Reliability Panel AEMC

DRAFT REPORT

GENERATOR COMPLIANCE TEMPLATE
REVIEW - 2019

19 SEPTEMBER 2019

Figure 1 Suggested Change to Align with GTPS Rule

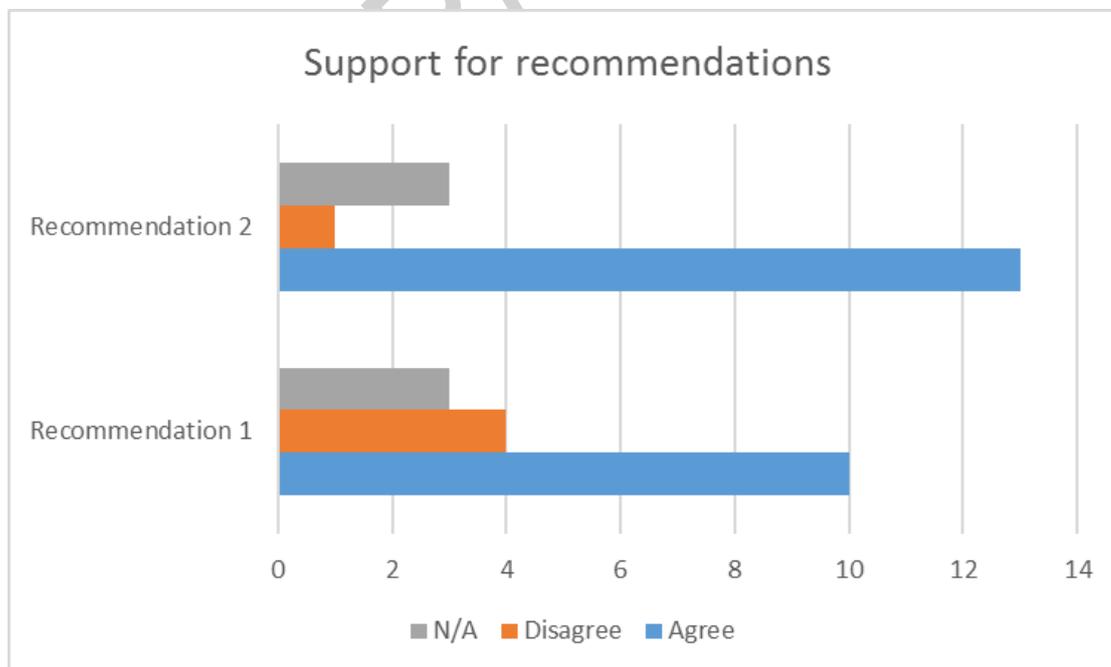
Our review identified two potential changes to the methods in the template and stakeholder feedback was sought regarding the merit of proceeding to implement the recommended changes. Figure 1 shows the level of support received from stakeholders for the recommended changes.

The GTPS rule changed S5.2.5.5 to including an explicit requirement to ride through multiple disturbances and requirements to inject or absorb reactive current to support power system voltages during the fault. The GTPS rule also clarified obligations for continuous uninterrupted operation. Monitoring the performance of the generating system during faults using high speed recorders should provide a suitable means of assessing compliance with the revised aspects of this performance standard and the ability to maintain continuous uninterrupted operation. To demonstrate suitable performance the generating system should remain in continuous uninterrupted operation unless the disturbances are more severe than the ride through events specified in the generator performance standard.

Figure 2 Use of methods in the compliance program template (S5.2.5.1 – S5.2.5.9)

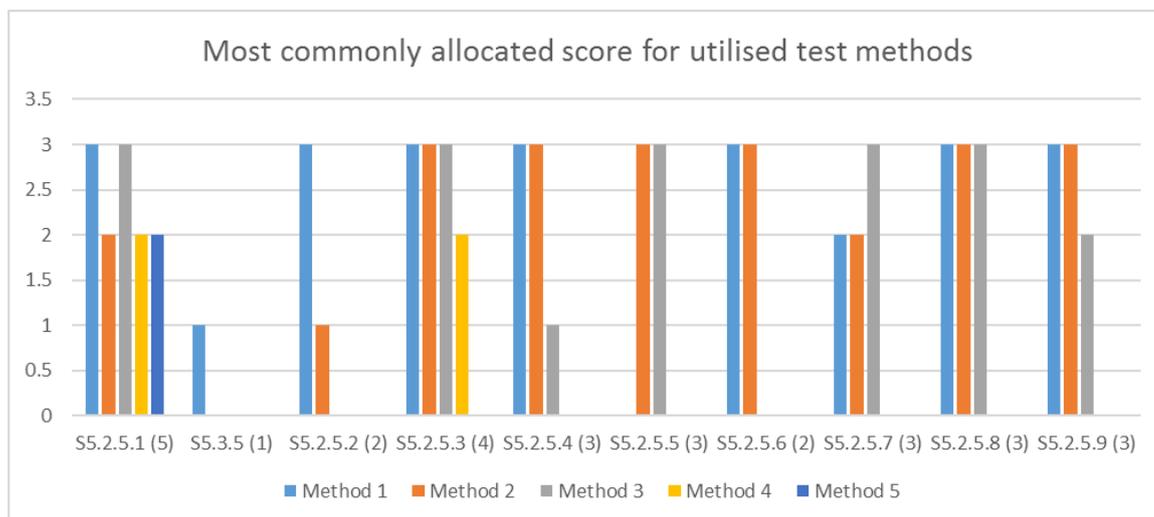
Responses provided by generators for the performance standards shown in Figure 2 revealed that:

Key insights drawn from the survey responses for each of the performance standards shown in Figure 2 are provided below:

Figure 3 Use of methods in the compliance program template (S5.2.5.10 – S5.2.8)

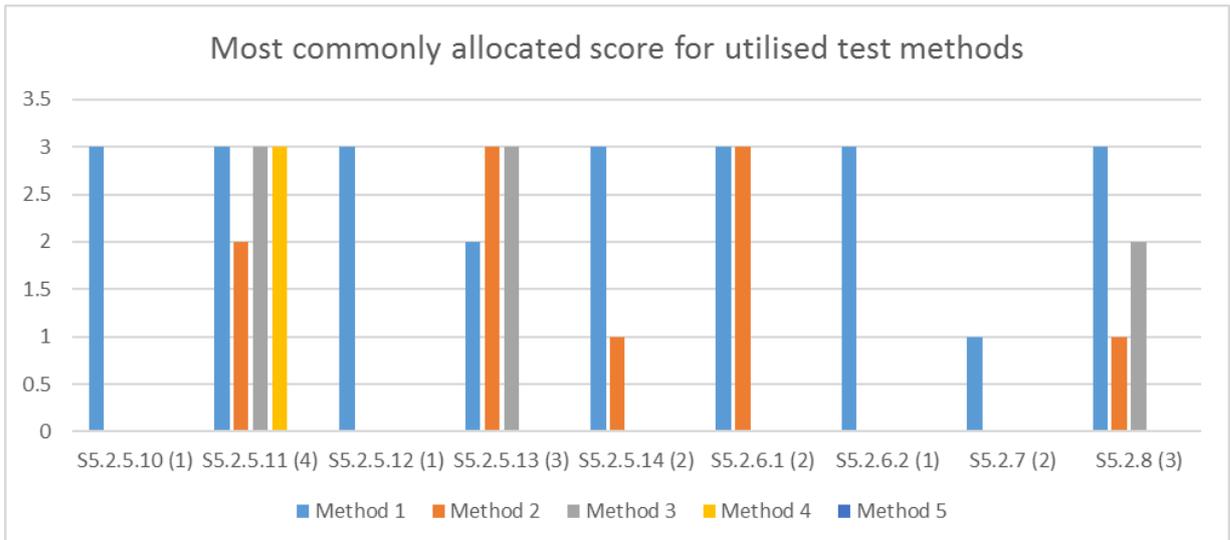
Responses provided by generators for the performance standards shown in Figure 3 revealed that:

Figure 4 Stakeholder feedback on GHD observations

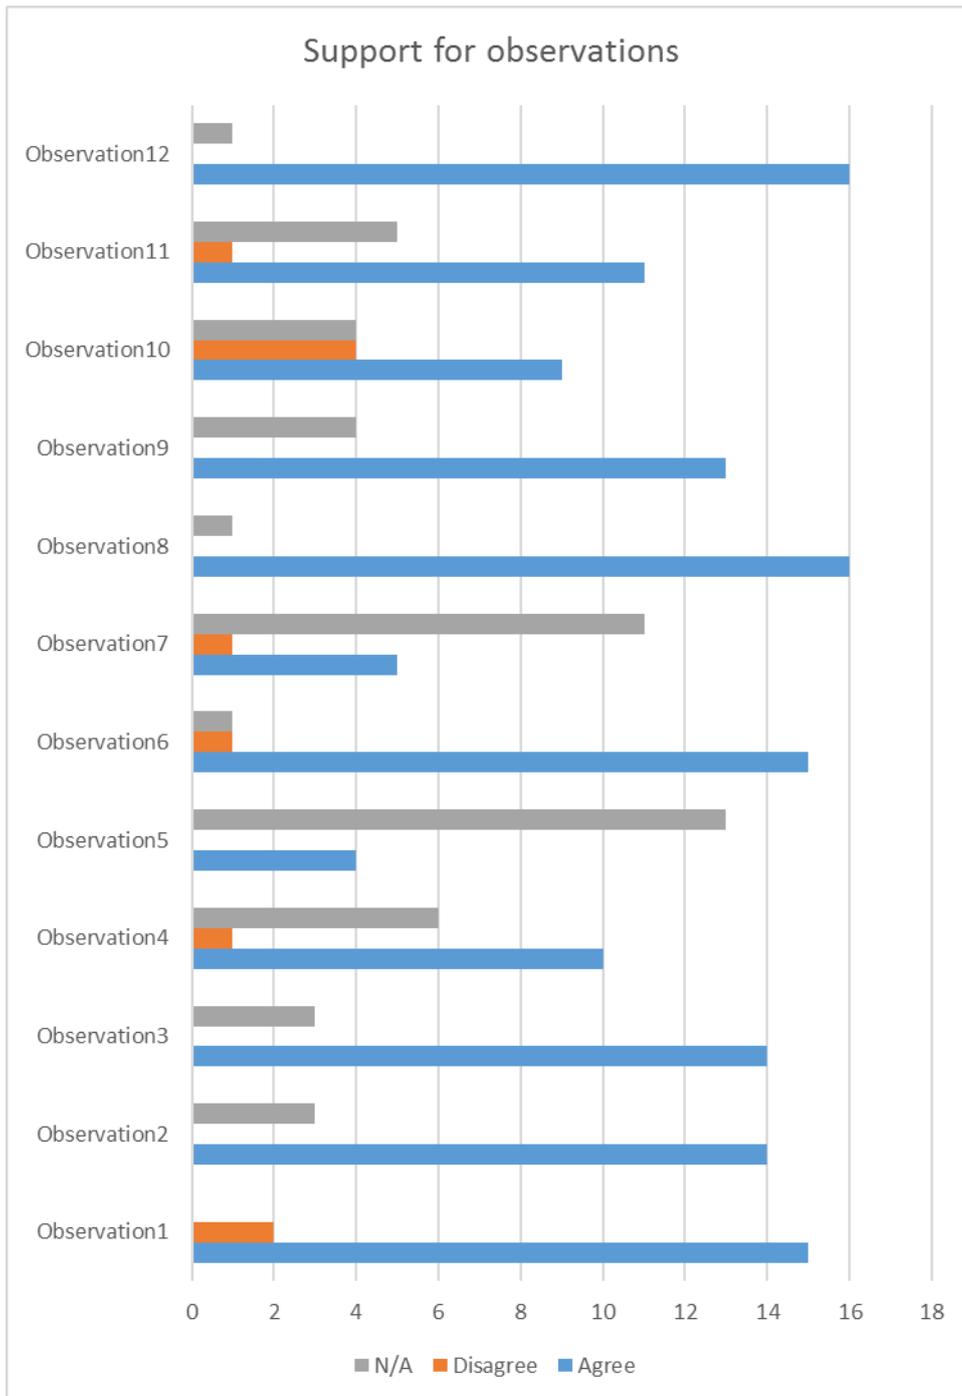
GHD completed an initial review of the template and identified a number of suggested changes or clarifications that could be made to improve the template. Through the survey, stakeholder feedback was requested on each of the suggested changes or observations made by GHD. Figure 4, below summarises the feedback received with coloured bars used to identify the number of stakeholders that:

The following sections present each of the observations made by GHD suggesting potential opportunities to refine the template and a summary of the response provided stakeholders.
